Request for Further Information from Trans-Tasman Resources Limited (TTR)

I refer you to your letter dated 13 October 2016, requesting TTR to address a number of questions as directed by the Decision-making Committee (DMC).

Discharges of Sediment including its off-site dispersion

Figure 1: Time series graphs of SSC levels at Graham Banks

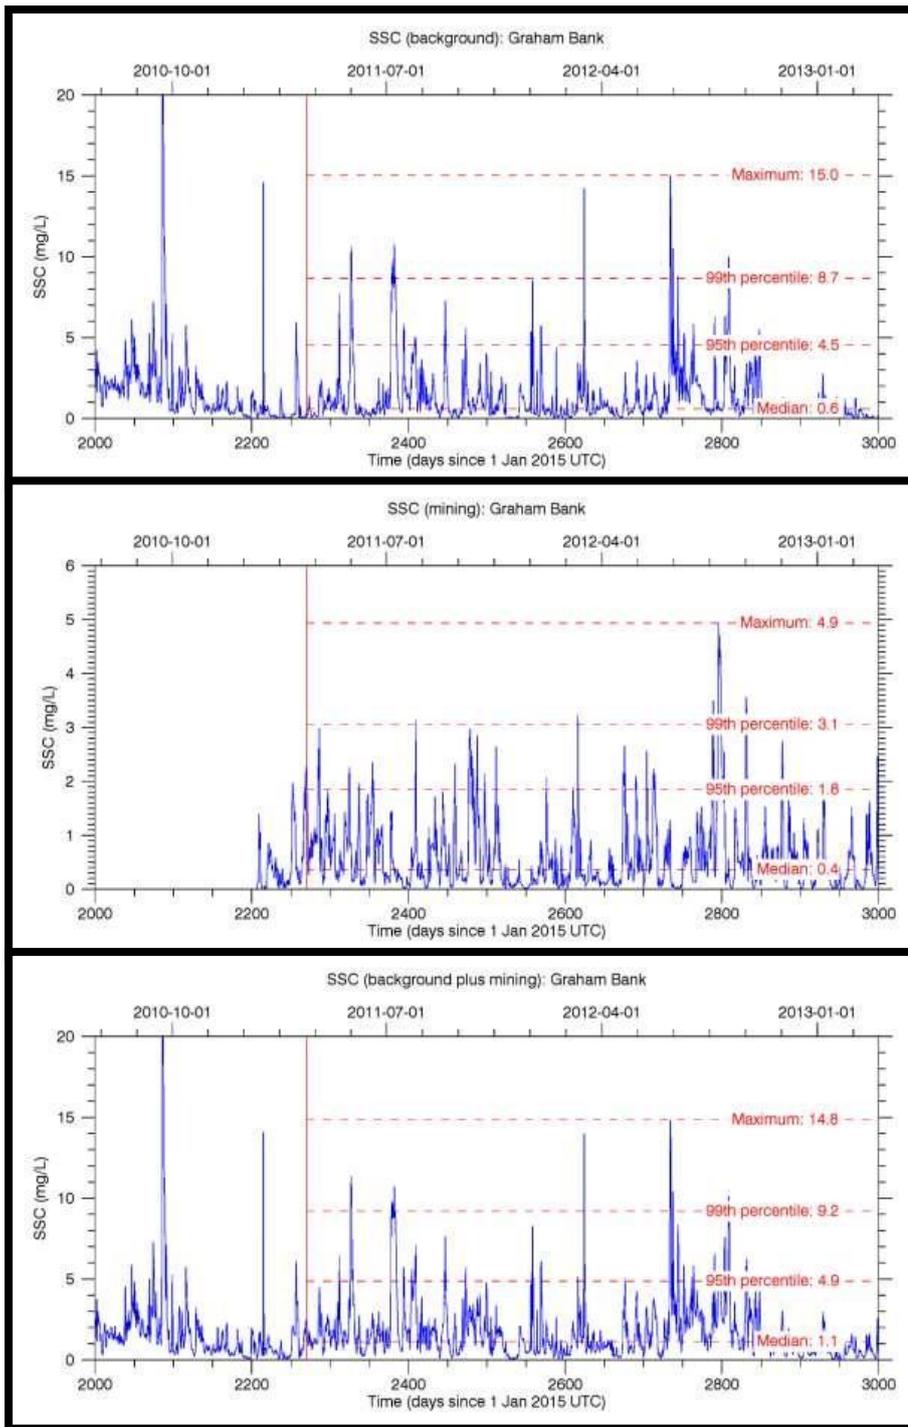
3. **What are the relevance of the 'net differences' (predicted increases) in median and 99th percentile suspended sediment concentrations (SSC) at the three locations discussed in section 4.4.2.3 of the Impact Assessment? (relevant EPA expert - GHD)**

The important thing is that for 50% of the time the differences will be at or less than the median with increases of 0.4 to 1.5 mg/L depending on distance from operations, wind direction etc. The corresponding range for 99th %ile is 5.5 to 10.8 mg/L i.e. for 1% of the time or less the environment would receive these levels or higher. The time series shows that such levels would occur as spikes for less than 7-10 days (see time series data below noting the different scales for the mining plot. Note – the time series plots do not form part the technical reports referenced in the Impact Assessment however, they will be introduced in the evidence of Dr Mark James as part of the hearing process). The fauna present can tolerate such spikes as we also see in the natural background, noting that we have used 95%iles for the upper limit of background at which time a management response would be required. The median level net differences would not be ecologically meaningful for fauna found in the region.

Phytoplankton, macroalgae, and microphytobenthos found in the South Taranaki Bight are already well adapted to the scale and pattern of variability in light availability. They can adapt rapidly, particularly for the microscopic producers, and operate on the order of hours and do so on a daily basis. They have significant ability to respond to alterations in the light field at time scales greater than an hour or so. Macroalgae can also adapt over the longer term by storing photosynthetic products, which is an additional advantage of large body size. Thus the temporal patterns of light attenuation by mining activities at the modeled sites (not directly at the mining site itself) will be well within the bounds of adaptation and therefore not significantly driven by the mining-driven pattern of light availability.

Figure 2: Particle size distribution graph of the run of mine and the discharge sediment

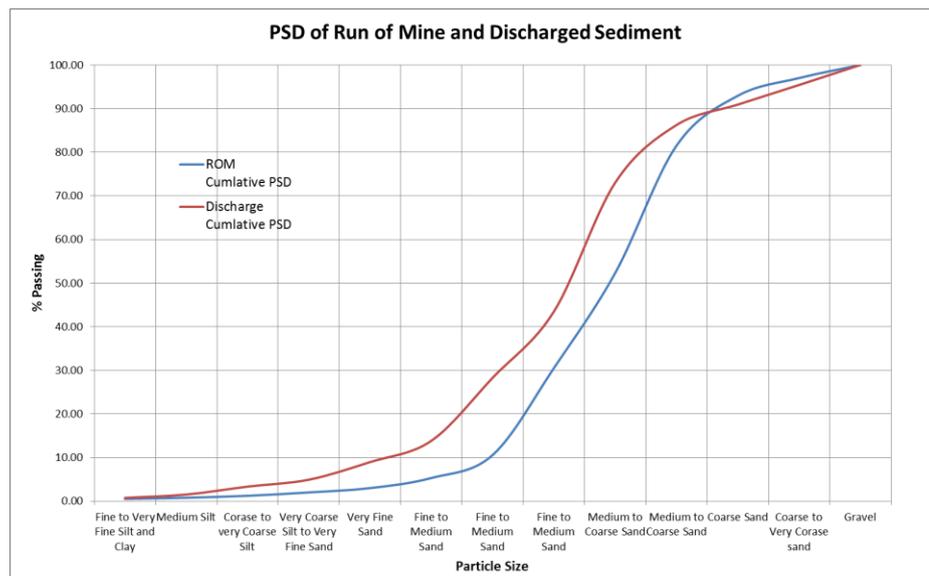
6. What is the final particle size range of the discharged post-processing material (de-ored sediment) compared to the material extracted?

Figure 2 below shows the comparison between the ‘run of mine sediment’ and that of the ‘discharged sediment’ and shows that there is a significant difference with the particle size distribution of the discharged sediment. On average, over the particle size distribution range, there is a 6% difference for the ‘run of mine sediment’ and the ‘discharge sediment’, with the discharge sediment having a higher proportion of fines (very coarse silt and finer sediment).

The PSD has not changed from what was used for the first plume model generated for the 2013 TTR marine consent application.

Figure 3: Locations of the bulk samples processed by TTR and the locations of the samples sent to HR Wallingford (circled)

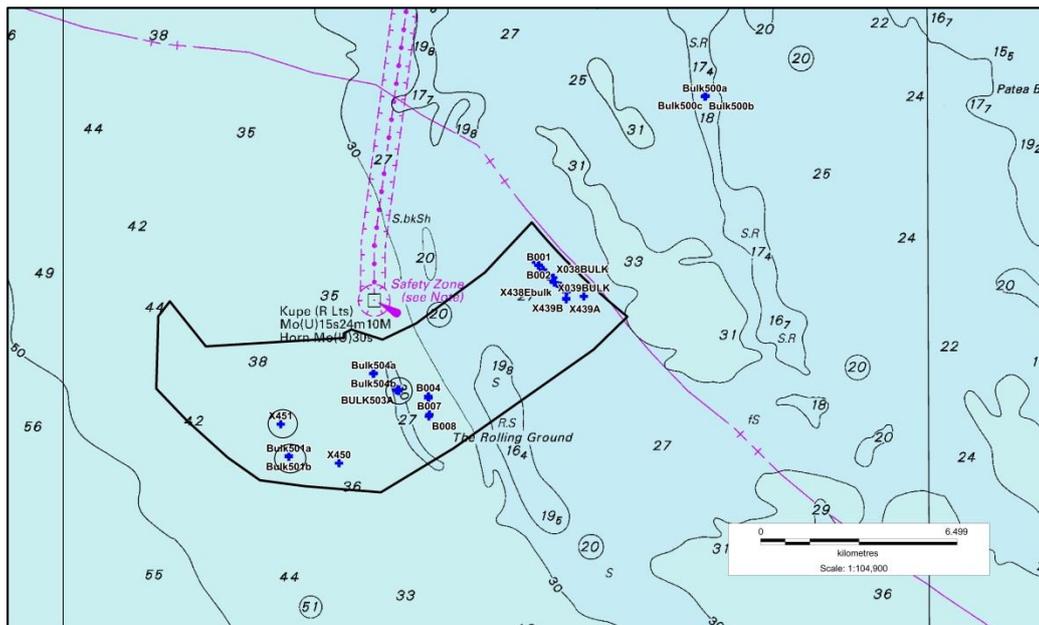
10. **Where were the three samples that HR Wallingford (HRW) tested collected from and do they reflect the nature (in particular the ranges of particle sizes) of the post-processing sediment proposed to be discharged? What was the chain of custody process associated with the collection and processing of these samples?**

The three samples sent to HRW Wallingford, to be tested, were collected from post processed sediment samples, processed at TTRs pilot plant facilities at Porirua. These samples reflect the sediment that will be discharged.

The extracted bulk samples were taken from multiple drill holes over specific locations and consist of up to 3.2 tonnes per sample. The bulk samples were from three separate locations, as shown in Figure 3. These three samples are part of the 13 bulk samples taken within the

proposed project area and are representative of all the bulk samples tested and of the minable iron sand sediment.

Figure 4: Schematic diagram of the recovery rates within disturbed sediments. Taken from Dernie et al (2003)

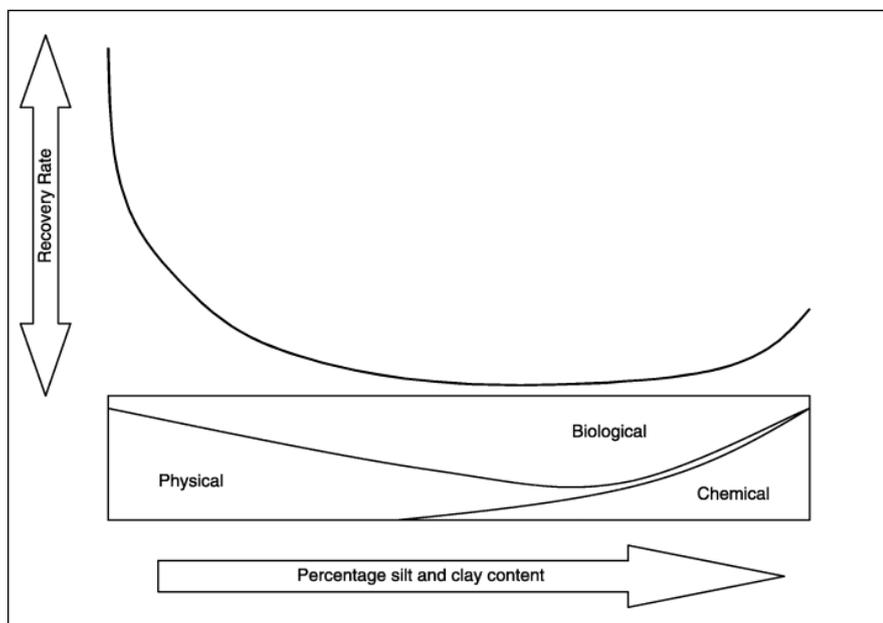
- 21. What are the expected recovery scenarios (timeframes) in relation to benthic communities within the mining area? What does the expected recovery look like both spatially and temporally? Graphic illustrations of the temporal recovery of benthic communities are requested.**

The benthic community in the STB where the iron sand recovery would take place occurs in a very exposed, high energy, highly dynamic sandy environment and is thus subjected to episodic disturbances from wave events and river inputs during high rain-fall events. The existing benthic community is dominated by short-lived, opportunistic and early successional or colonisation stages, with a very low abundance of longer lived organisms, indicative of an environment that is regularly disturbed.

There is now a good body of information available in New Zealand and overseas on benthic community recovery rates in more sheltered locations following sediment plume and sedimentation events as a result of dredging and other activities. For example, Port Otago studies have showed that it took up to 6 months for a disposal site in Blueskin Bay outside the harbour entrance to recolonise and have a similar community to a site protected from disposal.

Recolonisation following sand disposal, which is the main type of material to be considered with the TTR application, was much quicker with the community being similar to pre-deposition on a time scale of weeks. This is consistent with experimental studies undertaken in Menai Strait, North Wales that showed clean sand communities had the most rapid

recovery rate following disturbance, whereas communities from muddy sand habitats had the slowest physical and biological recovery rates (Dernie, et al. 2003).

Surveys following dredging at the Port of Auckland and disposal of 262,000 m³ in the Hauraki Gulf found there was an initial increase in species abundance and diversity of benthic communities, then a reversion to baseline conditions. Early successional communities, which included the likes of tube-dwelling polychaetes, were evident immediately after disposal followed by an increase in longer lived successional stages 8 and 11 months after disposal.

Generally, communities associated with sand in high energy environments are very frequently disturbed and are likely to be continually in an early transitional stage. The longer lived species in these communities, such as large starfish (which were found at low densities of 6 per ha in the proposed mining area), could take several years to fully recover in the area where sands are extracted and re-deposited. But there is likely to be some movement of these mobile species into the area immediately after the iron sand recovery activities move to the next block.

In summary, the dominance by early successional stages in the area where the actual excavation and sand re-deposition takes place means that recovery should be relatively rapid and likely to be at the scale of months. Recovery of some taxa such as small polychaete worms would be expected to start within a few weeks of the ISR operations moving elsewhere within the consent area. However larger, long-lived biota could take months to several years to fully recover in the excavation area.

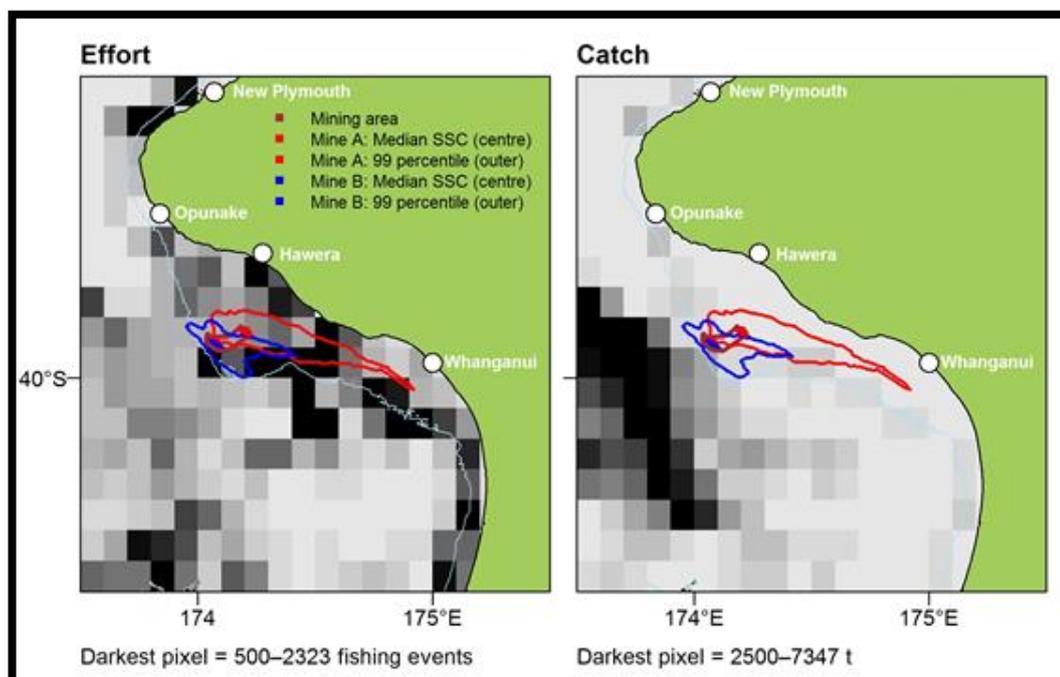
- 26. What are the overlaps between the project area and commercial fishing and what species are present that could be affected. A graphic illustration is requested.**

These are detailed in a report by NIWA titled 'South Taranaki Bight Commercial Fisheries' provided as Report #18 in the 'Reports Referenced in the IA' package.

The overlap of the mining area and sediment plumes with overall commercial fisheries effort (numbers of fishing events) and catch (t) is provided in Figure 3-1, (copy below) with this

overlap explored for each fishing method in subsequent figures. The commercial fisheries potentially affected are described in detail in the NIWA report, but in summary:

- The fisheries with the greatest overlap with the proposed iron sand extraction operations are the bottom trawl fisheries for leather jackets and trevally;
- The set-net fisheries for rig, carpet sharks, trevally, school shark, snapper, and spiny dogfish;
- Between 5% and 17% of the total catches in the study area for these species occur in the area where SSC exceeds the 2 mg/l threshold for fish avoidance 1% of the time; and
- The area where SSC exceeds the 2 mg/l threshold for fish avoidance 50% of the time is small and negligible compared to the scale of the fishery in this quota management area.
